REMARKS/ARGUMENTS

Application No. 09/773,605 SUGI0064

FIG. 7

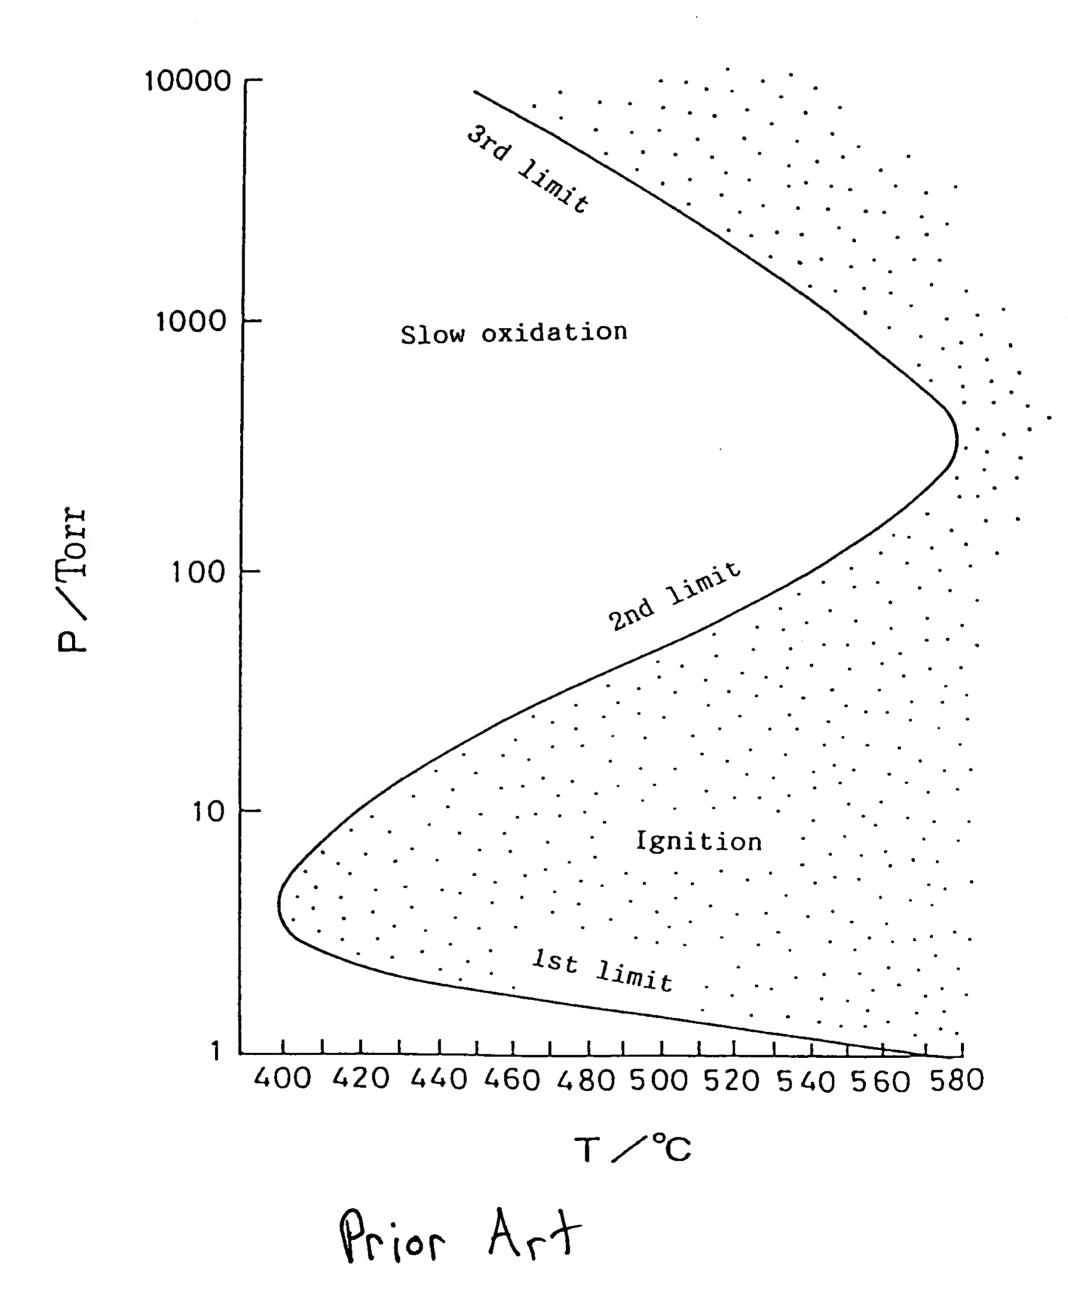
The drawings have been corrected in accordance with 37 C.F.R. § 1.85. Specifically, Figure 1 has been amended to add the character reference "WVG" that was previously omitted. Figure 7 has been labeled "Prior Art." The present changes to the drawings adds no new matter to the application.

Applicants note the Examiner's objection to Figures 5 and 6 on the grounds that these figures should be labeled "Prior Art" (Office Action, dated February 12, 2004, page 2, lines 13-14). Applicants disagree that the term "Prior Art" is applicable to the subject matter shown in Figures 5 and 6 of the present application. This material is prior work of the present inventor and assignee previously submitted to the Japanese Patent Office. However, this subject matter is not valid prior art against the instant claims under 35 U.S.C. § 102.
